1. Documents related to the consent

~~(Amended – MOD/2023/0247 – 28/11/2023)~~
(Amended – MOD/2024/0453 – INSERT DATE)

2. Design Change

Figure 1: Openings subject to condition 2A that need to be readable as former openings

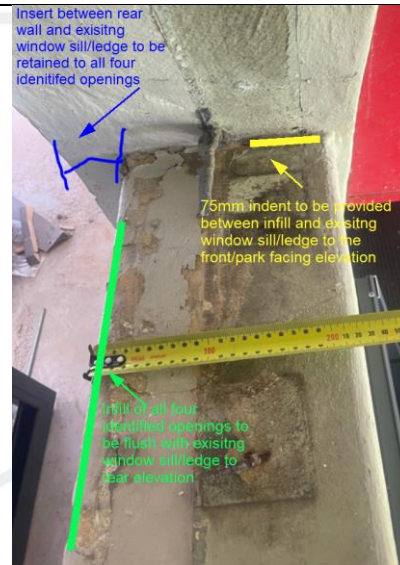
Prior to the issue of a Construction Certificate for MOD/2024/0453, detailed drawings of each of the four (4) remaining window openings, identified in Figure 1, must be provided to, and approved by, Council's Heritage Specialist, including plan, elevation and sections. The drawings must demonstrate:

- a. *Lightweight infill construction or block work, hebel, or clay brick, or similar, achieving 120/120/120 fire rating; and***
- b. *To ensure that the openings remain legible as former openings (excluding the door section), as shown in Figure 2:***

- i. At least a 75 mm indent from the internal south-east elevation (interior) – as highlighted in yellow in Figure 2; and
 - ii. The existing insert between the existing external wall of the Grandstand at the rear (north-west elevation (exterior) and the existing window sill/ledge towards the rear must be retained – as highlighted in blue in Figure 2.
 - iii. The infilling of the openings must be flush with the edge of the existing window sill/ledge at the rear – as highlighted in green in Figure 2; and
- c. The indented infill construction to the window openings shall be painted in a darker shade of the approved Murobond Cement Paint to both the south-east elevation (interior) and north-west elevation (exterior) to ensure the filled in window openings can be interpreted.
